Title: Dorset Road– Contraflow Cycling Traffic Order

Title: Dorset Road and StMichaels Terrace – Local Cycling Measures

ST MICHAELS TERRACE  
& DORSET ROAD  
PRELIMINARY DESIGN

CH2017\_18 PD 001  
PLACE & SUSTAINABILITY  
SINGLE FRONTLINE

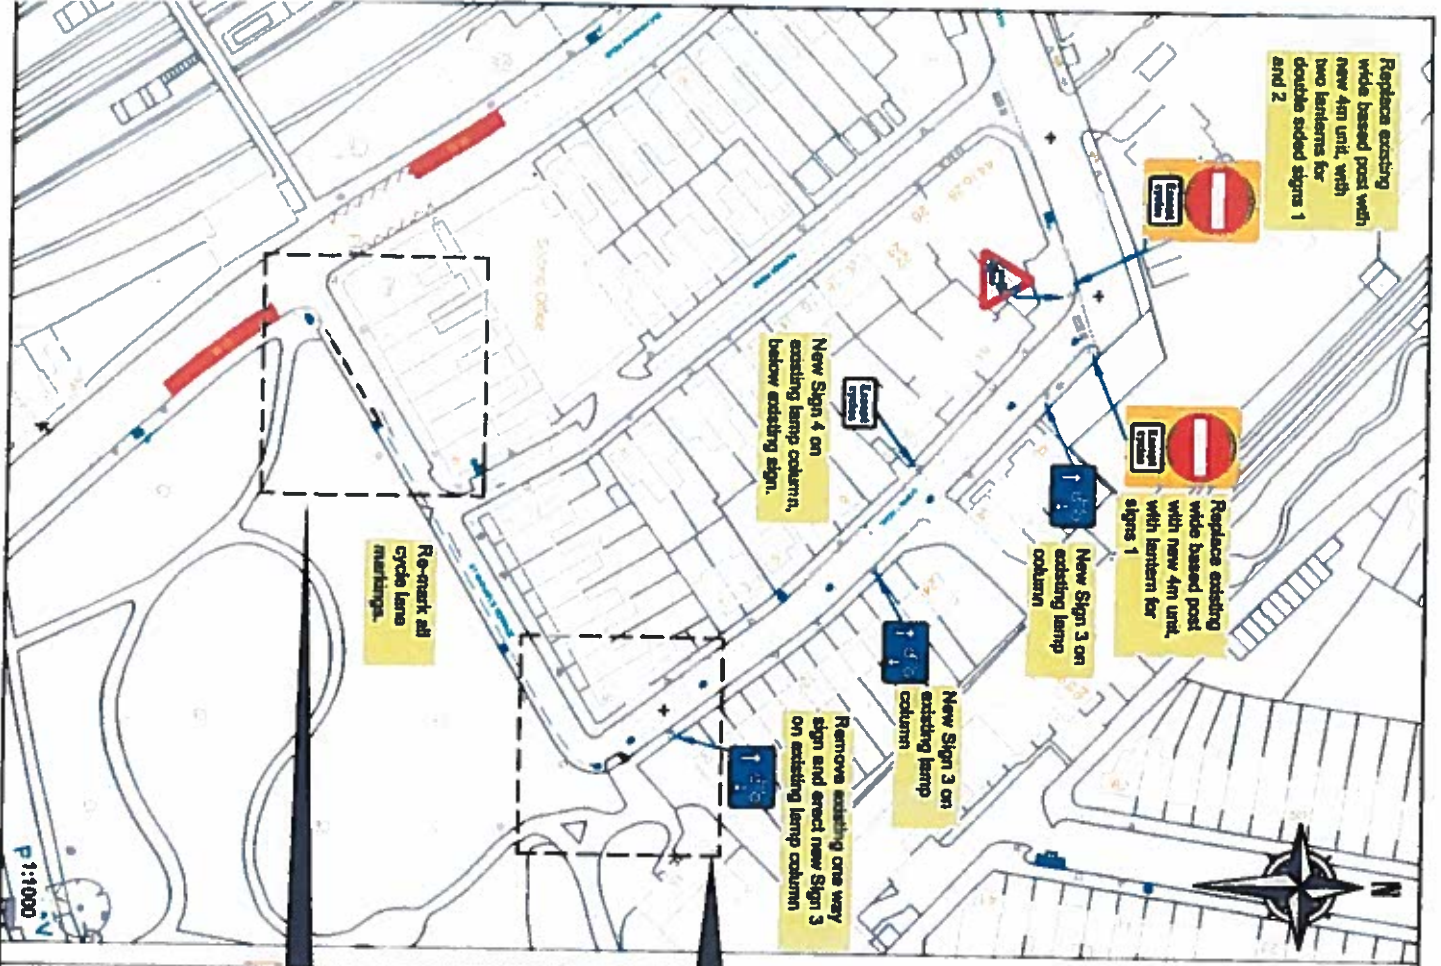
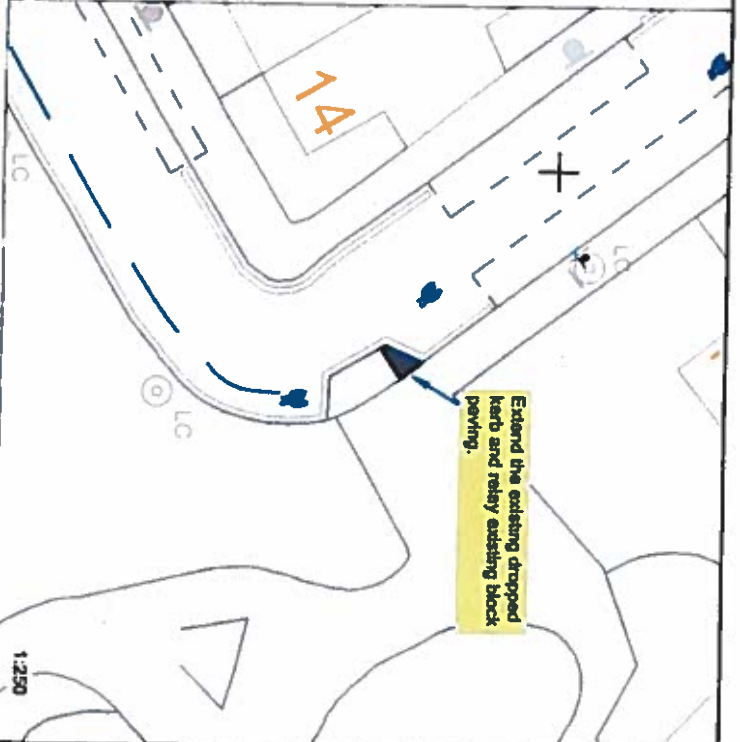
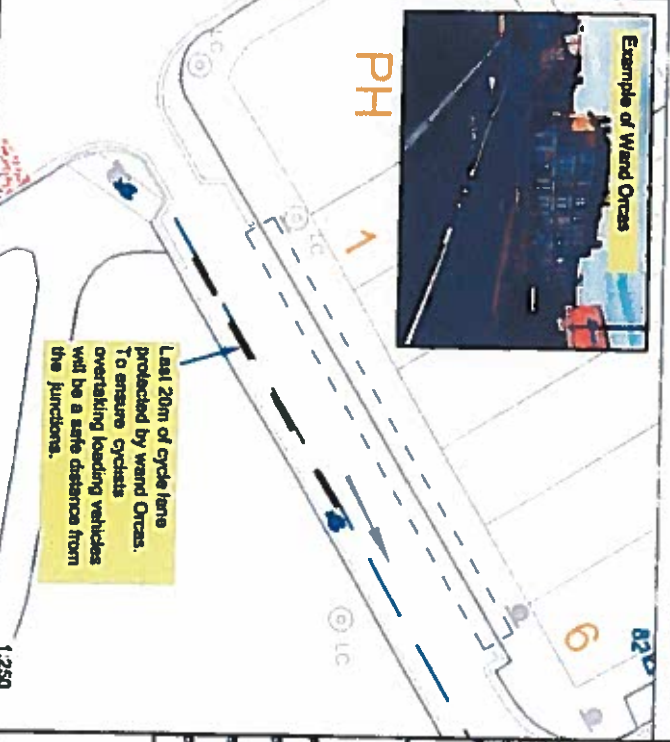
*'I strongly disagree with the proposals to install a contraflow system for cyclists on this road. I believe this would be dangerous for cyclists and is unnecessary.'*

*The road is quite narrow and has necessary permit parking on both sides for local residents cars. There is simply not enough space for cyclists to safely navigate this road against the motor vehicles driving in the other direction - these often include large refuse removal trucks and builders vehicles.*

*I cannot understand why such a scheme is necessary, given the current arrangement of a dedicated cycle lane leading from Station Road along St Michaels Terrace which allows cyclists to safely ride through from Alexandra Palace to Bounds Green Road.*

*I therefore disagree with the proposal on the grounds of safety and waste of council tax payers money.'*

Overall Support / Object	Comment	Response
Other view	<p>Thanks for the notification. I have concerns about this - also Dorset Road is used by only about 10 cycles a day at most. The road and pavements are both quite narrow with vehicles parked on both sides. Any cycle lane added to will only make it even narrower. Vehicles parked in the street have been hit by passing traffic as it is. It is not very clear what is intended, so more detail is required please.</p>	<p>The cycle separators are to be installed only in StMichaels Terrace where the existing contraflow lane and waiting restrictions are being abused.</p> <p>There will be no narrowing of the carriageway or footway. Aside from signage, no additional infrastructure will be installed in Dorset Road.</p> <p>The low levels of traffic will allow the contra-flow to operate under a give and take basis using the pre-existing passing gaps created by driveways. The layout is in line with London Cycle Design Standards</p>

Object	<p>I object to the plan for contra-flow cycling in Dorset Road. Dorset Road is one way for a reason; it is narrow. Bin wagons and lorries get through if we all park carefully and we do. Most of us also turn in our wing mirrors having learned the hard way what happens if we don't. Cars are of course smaller, but they still take up most of the width of the road. Cyclists sometimes speed the wrong way, but if they meet an oncoming car, they pause and tuck in if you are lucky. In your new plan who would have right of way? This has not been properly thought through. Has anyone been to measure available space? What is wrong with cyclists continuing to use the existing one-way system. They can already ride up as well as down St. Michael's Terrace. Incidentally, cyclists' behaviour crossing the</p>	<p>The cycle separators are to be installed only in St Michaels Terrace where the existing contraflow lane and waiting restrictions are being abused.</p> <p>There will be no narrowing of the carriageway or footway. Aside from signage, no additional infrastructure will be installed in Dorset Road.</p> <p>The low levels of traffic will allow the contra-flow to operate under a give and take basis using the pre-existing passing gaps created by driveways. The layout is in line with London Cycle Design Standards and the scheme has been subject to Road safety auditing.</p> <p>Haringey Cycle campaign have requested these changes.</p> <p>This alteration will allow a quiet route to the local cycle route</p>

Object	<p>Dorset Rd is too narrow to keep both the existing parking bays (which are much needed) and add</p>	<p>The cycle separators are to be installed only in StMichaels Terrace where the existing contraflow lane</p>

<p>in a cycle contraflow lane.. It could potentially be dangerous. Cyclists crossing the main bridge should follow the main road and then turn into St Michael's Terrace after the pub. Agree that cycle lane in St Michael's Terrace should be retained and improved - as proposed. Parking in it, as presently practiced, is to be forbidden at all times</p>	<p>and waiting restrictions are being abused.</p> <p>There will be no narrowing of the carriageway or footway. Aside from signage, no additional infrastructure will be installed in Dorset Road.</p> <p>The low levels of traffic will allow the contra-flow to operate under a give and take basis using the pre-existing passing gaps created by driveways. The layout is in line with London Cycle Design Standards and the scheme has been subject to Road safety auditing.</p> <p>Haringey Cycle campaign have requested these changes.</p> <p>This alteration will allow a quiet route to the local cycle route through nightingale Gardens. As it does not adversely affect the operation of the road or the level of service to residents, we have been happy to progress them.</p>

<p>Object</p>	<p>Object to the DORSET ROAD AND ST MICHAEL TERRACE N22: PROPOSED CYCLE CONTRA-FLOW AND CYCLE SEPARATORS. I live at st michaels terrace, and every morning and evening, I or my wife have to walk through Nightingale Gardens to get our 16 month old son to nursery. He likes to toddle through the park alongside us. While I have nothing against cyclists (I cycle to work most days), the bend at the entrance on nightingale gardens from st michaels terrace is a real blind spot. Cyclists come tearing around it very fast and sometimes I have to pull my son off the path so he doesn't get run over. If I could suggest:          ·Blind spots in nightingale gardens is improved (with mirrors).          ·A U-chicane used to decrease speed of</p>	<p>The cycle separators are to be installed only in StMichaels Terrace where the existing contraflow lane and waiting restrictions are being abused.</p> <p>There will be no narrowing of the carriageway or footway. Aside from signage, no additional infrastructure will be installed in Dorset Road.</p> <p>The low levels of traffic will allow the contra-flow to operate under a give and take basis using the pre-existing passing gaps created by driveways. The layout is in line with London Cycle Design Standards and the scheme has been subject to Road safety auditing.</p> <p>Haringey Cycle campaign have requested these changes.</p> <p>This alteration will allow a quiet route to the local cycle route through nightingale Gardens. As it does not adversely affect the</p>

<p>cyclists at the entrance of the park from st michaels terrace. (This would also stop mopeds going down, Please see attached). Not spend money laying down infrastructure for cycle paths on Dorset road and st michaels terrace when the traffic on these roads is negligible (one car every fifteen minutes). Cyclists don't even stick to their lanes because of lack of cars. I have informed police in the past about mopeds using nightingale gardens cycle path.</p>	<p>operation of the road or the level of service to residents, we have been happy to progress them.</p>
--	---	---

I think it would be dangerous to have bikes coming the opposite way in Dorset Road because the road is narrow and has cars parked on both sides. How would the cycle separators work - it is not clear. Will the road become even narrower for cars? I understand that cyclists don't like them, either!

Dorset Rd is too narrow to keep both the existing parking bays (which are much needed) and add in a cycle contraflow lane.. It could potentially be dangerous. Cyclists crossing the main bridge should follow the main road and then turn into St Michael's Terrace after the pub. Agree that cycle lane in St Michael's Terrace should be retained and improved - as proposed.

against cyclists (I cycle to work most days), the bend at the entrance on nightingale gardens from st michael's terrace is a real blind spot. Cyclists come tearing around it very fast and sometimes I have to pull my son off the path so he doesn't get run over. If I could suggest: ·Blind spots in nightingale gardens is improved (with mirrors). ·A U-chicane used to decrease speed of cyclists at the entrance of the park from st michael's terrace. (This would also stop mopeds going down, Please see attached). Not spend money laying down infrastructure for cycle paths on Dorset road and st michael's terrace when the traffic on these roads is negligible (one car every fifteen minutes). Cyclists don't even stick to their lanes because of lack of cars. I have informed police in the past about mopeds using nightingale gardens cycle path, as seen in the photo. (See Card 7)

There will be no narrowing of the carriageway or footway. Aside from signage, no additional infrastructure will be installed in Dorset Road.

A traffic observation revealed that between 8-10 vehicle per hour travel along Dorset Road. The low levels of traffic will allow the contra-flow to operate under a give and take basis using the pre-existing passing gaps created by driveways. The layout is in line with London Cycle Design Standards and the scheme has been subject to an independent road safety audit by an external consultant. A post implementation safety audit will also be undertaken to make sure the arrangements are operating safely.

This alteration will allow a quiet cycle route access to the local cycle route through nightingale Gardens. As it does not adversely affect the operation of the road or the level of service to residents, we recommend that the proposal is progressed.

**10.1** Although five of the eight respondents have objected to these proposals, it is clear that there is some confusion as to how the contraflow cycling will operate in Dorset Road. And an assumption that infrastructure will be installed, that will be detrimental to parking and general operation of the street.

**10.2** Given that this contraflow route in Dorset Road and protection in St Michaels Terrace are two of the strategic aims of our partners at the Haringey Cycle Campaign and the at they can be progressed without adversely affecting the level of service currently enjoyed by residents in this area. We have recommended that this proposal be progressed as proposed.
